July 13, 2017

Reference: *Supplemental Site Investigation and Remedial Action Plan Review March 27, 2017 Email, April 28, 2017 Email, and June 14, 2017 email*
Former Wayne Pigment Corp.
300 South Barclay and 139 East Oregon Street
Milwaukee, Wisconsin
FID No. 241029470
BRRTS No. 02-41-553395 and 03-41-547627

KEY ENGINEERING GROUP, LTD.
File No. 1609-0017

FIGURE 9
MONITORING WELL MW-1
TRICHLOROETHENE GROUNDWATER TREND GRAPH
WAYNE PIGMEN CORPORATION
300 SOUTH BARCLAY STREET
MILWAUKEE, WISCONSIN

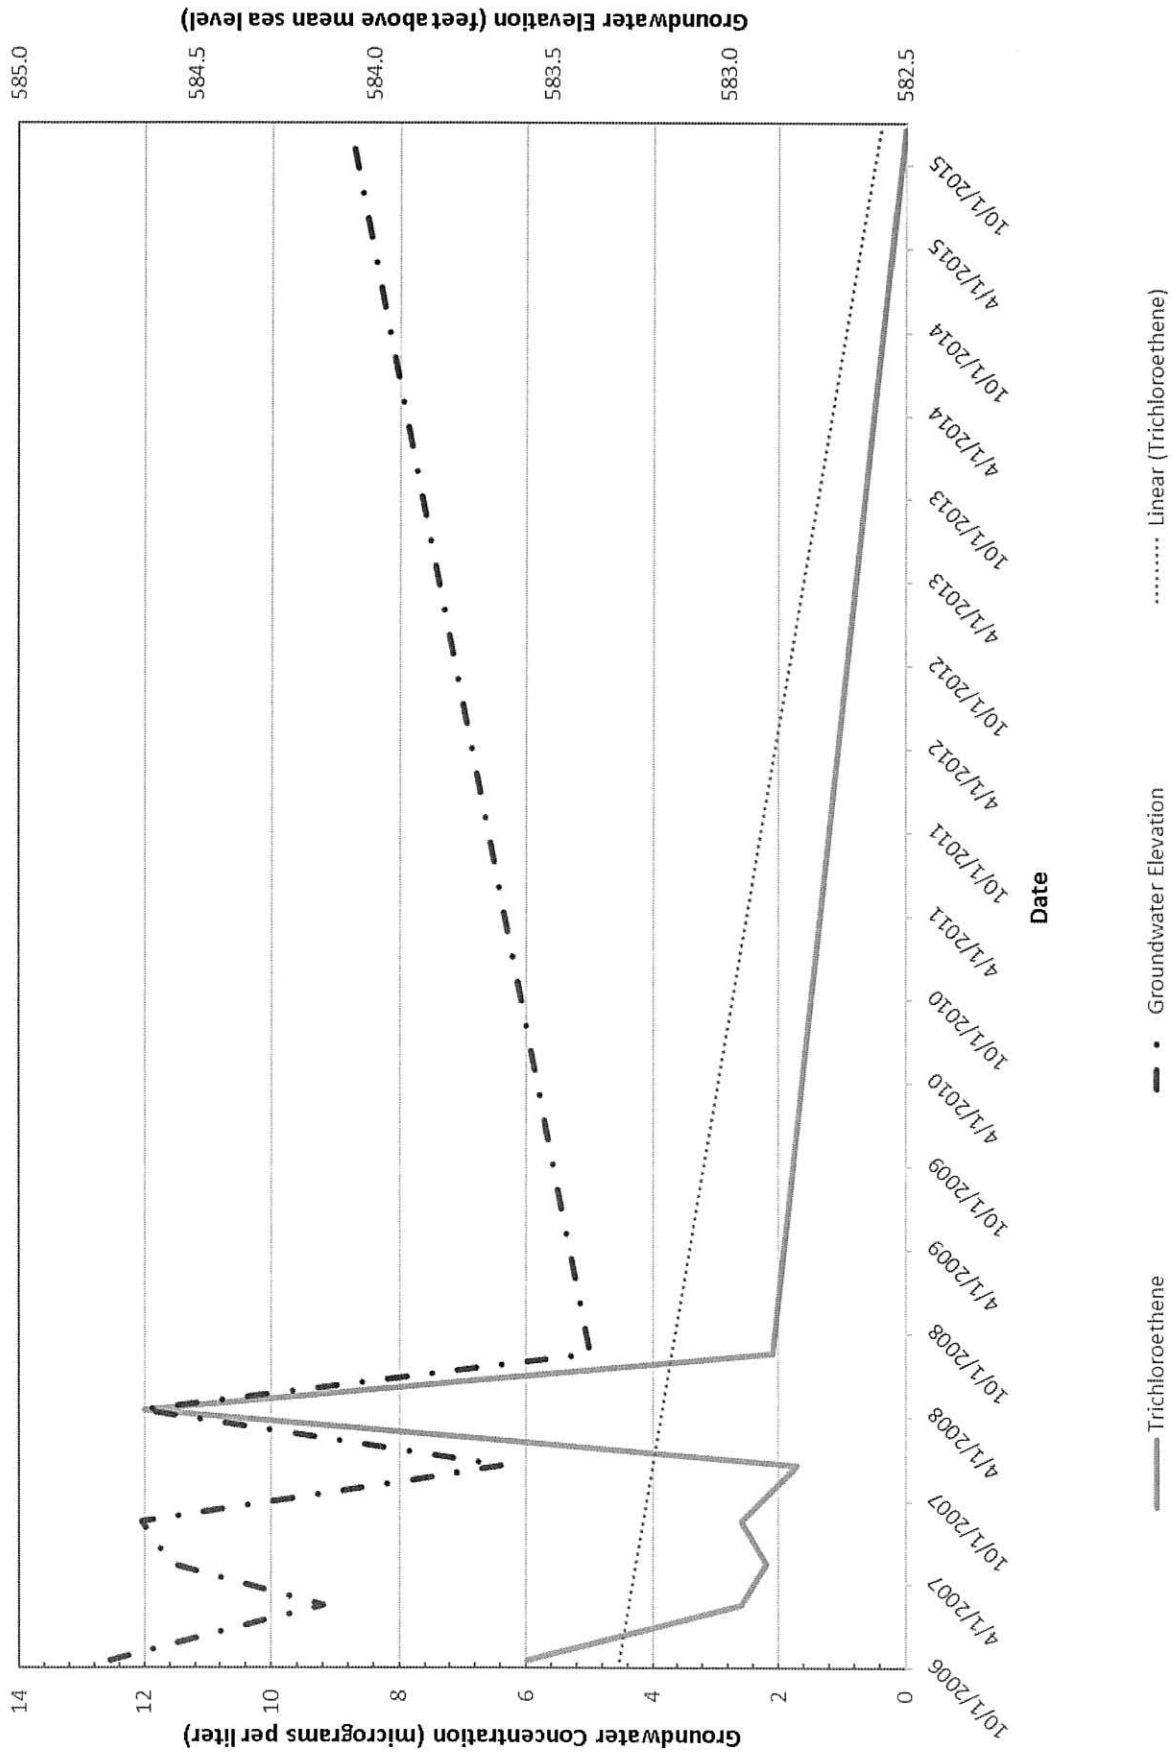
9. *Groundwater: Provide a more thorough discussion of groundwater contamination results including assessment of trends, where contaminants are migrating off-site and if and where remediation is needed. You identify need for remediation of TCE and metals. No discussion of PVOCs or PAHs is provided.*

A trend line graph for TCE in monitoring well MW-1 is presented as Figure 9. The chlorinated VOC concentrations continue to decrease over time.

SCALE	VARIES
PROJECT NUMBER	150302
SET TYPE	PLAN EXAMINATION
DATE ISSUED	07/12/2017
SHEET NUMBER	C 120

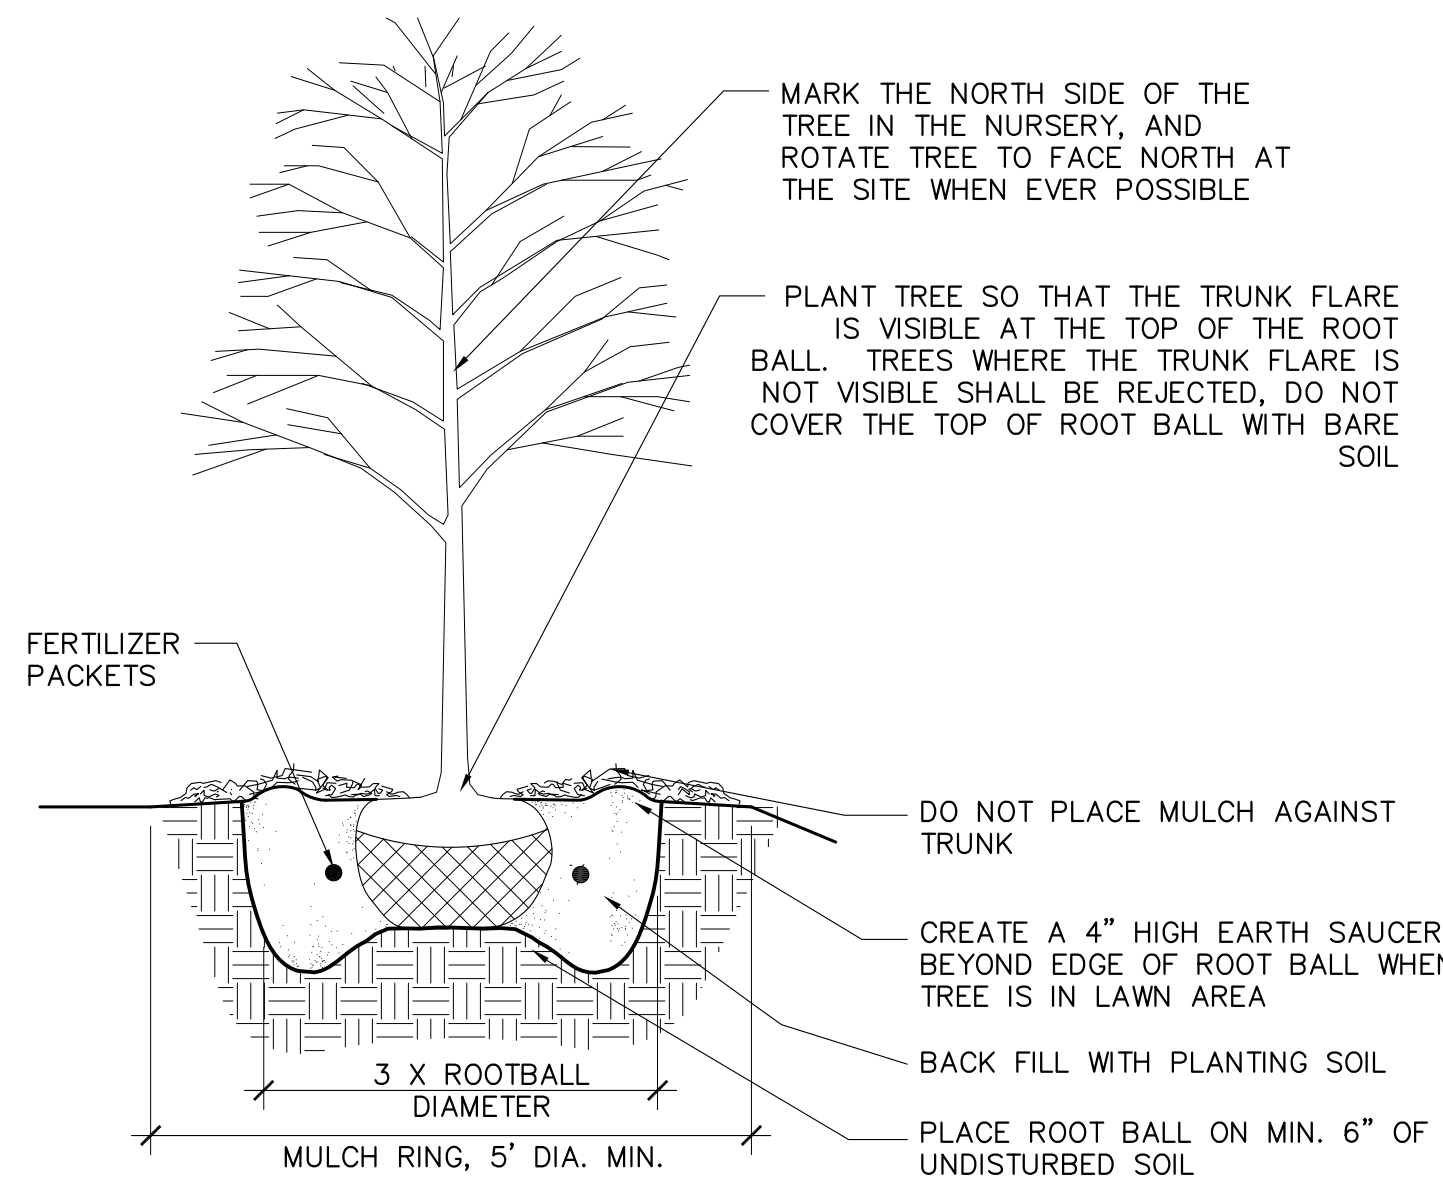
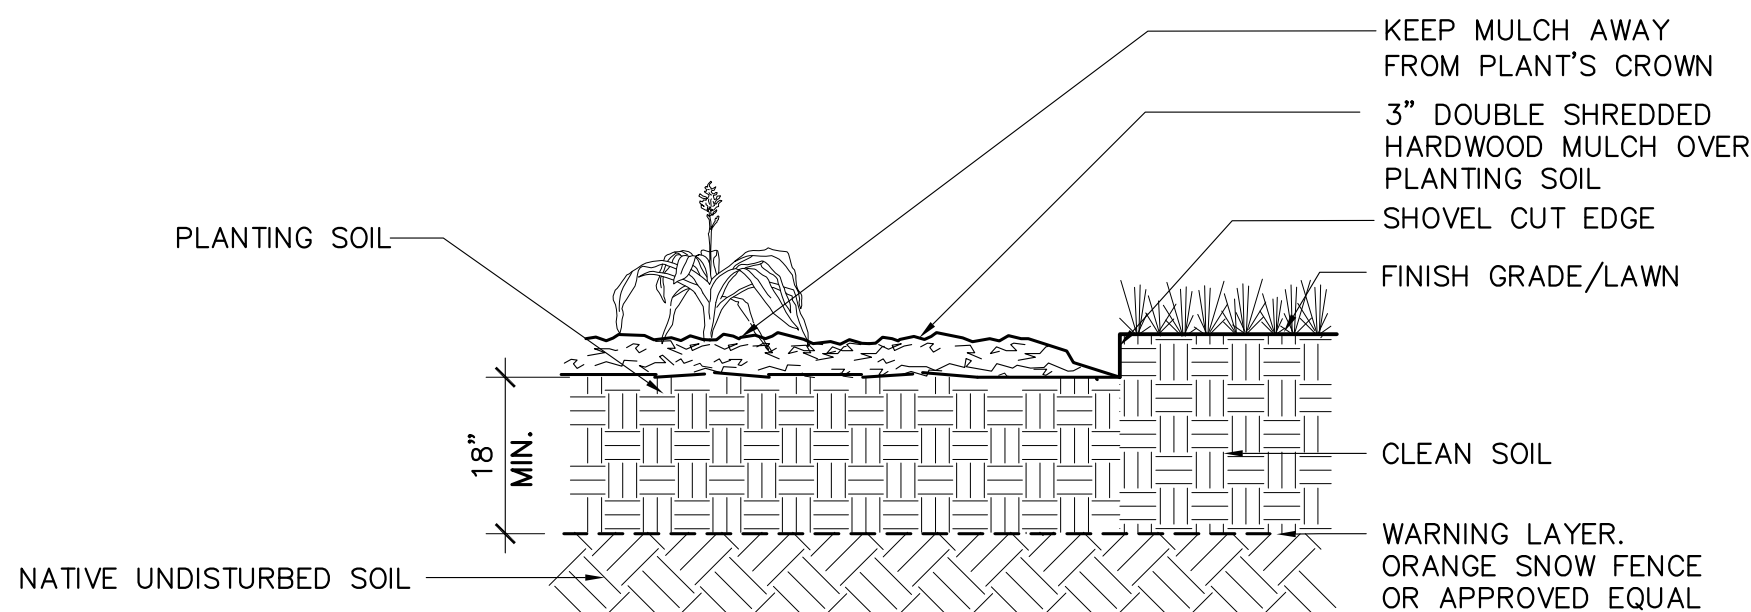
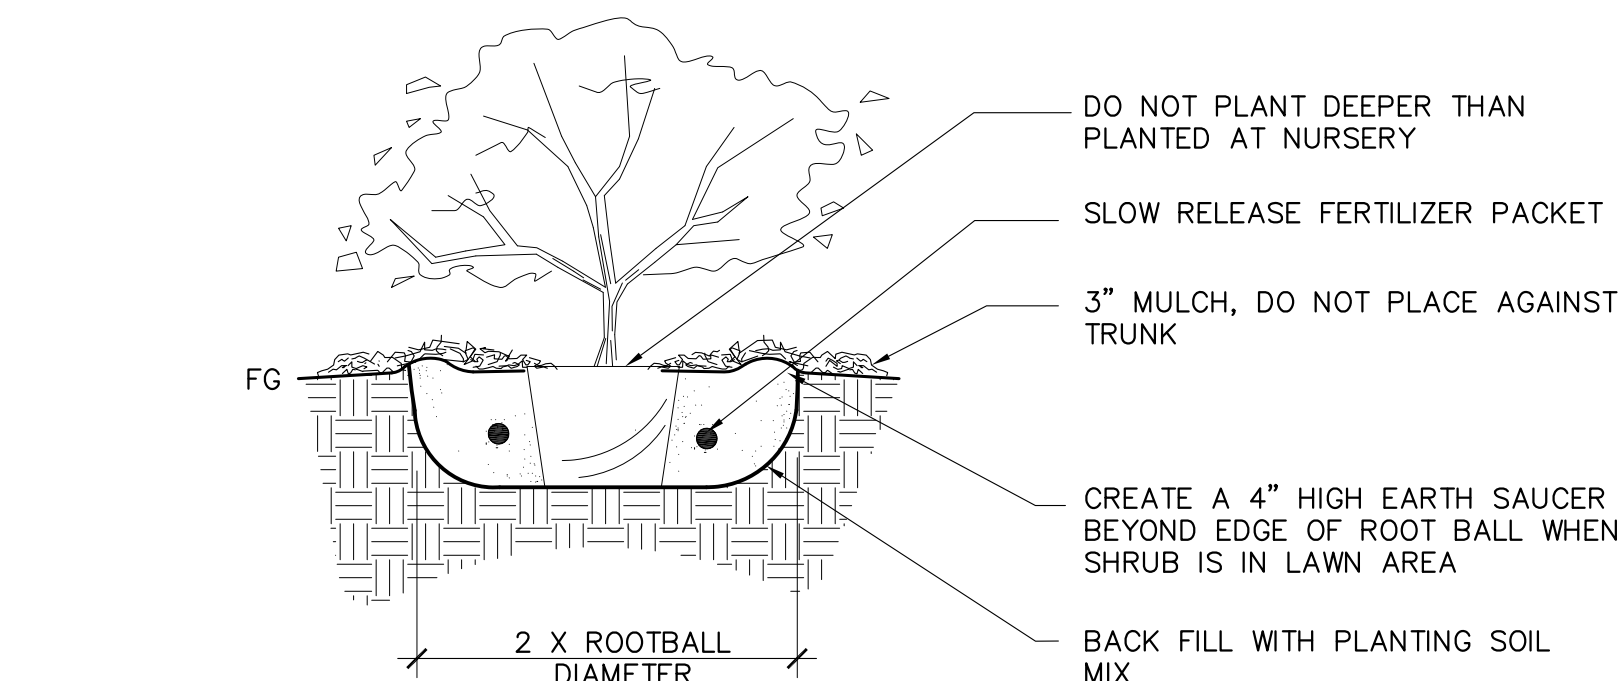
12. *Remedial Capping Plan: Provide more details regarding construction of the proposed landscaped areas including a description of the types of plants (root ball size) that will be used, and the depth required to accommodate the plantings. Areas requiring excavation that would produce potentially hazardous waste upon excavation should be identified prior to excavation. If applicable, haz waste management rules must be followed.*

13. *Provide discussion to support the proposed 1.5' thick soil cap. i.e. why it will be protective, can be maintained, etc. We will need details on where exactly the soil cap will be placed, the slope of any non-flat areas, etc. DNR may consider approving a cap of this thickness on the Oregon St. property based on your justification, however, may be more supportable if you add a warning layer. Based on the high concentrations of metals and PVOCs south of building 11, we will require something more protective for landscaped areas on the Barclay parcel. We expect that a capping plan for landscaped areas would ensure that contaminated soil will not be disturbed/encountered in the future. A thicker clean cap with possibly warning layer should be considered and a revised plan proposed.*

Landscape drawings are included in Attachment 1. The drawings show the location of landscaping, the proposed species to be planted, and the root size. Cross-sectional views of the plantings are also presented. Below is a summary of the barrier cap plan for landscaped areas at the site. The barrier cap will be installed during the construction phase. The landscapers will plant the areas following construction when the clean soil and warning layers are already installed.

A 1.5-foot soil cap is proposed on the Oregon Street property for areas that will be landscaped. The onsite topography for the landscaped areas is minimal. The proposed final topography and location of proposed landscaping are presented on the attached architect drawings. A warning layer consisting of orange or other bright color snow fence, or similar permeable material, will be installed between the impacted soil and overlying clean soil cap. Based on the landscape plan that will be developed, the soil cap will be extended to 3 feet deep and a minimum of 4 feet by 4 feet horizontally where a tree or root ball is greater than 1.5 feet is proposed to eliminate the concern of encountering impacted soil during planting.
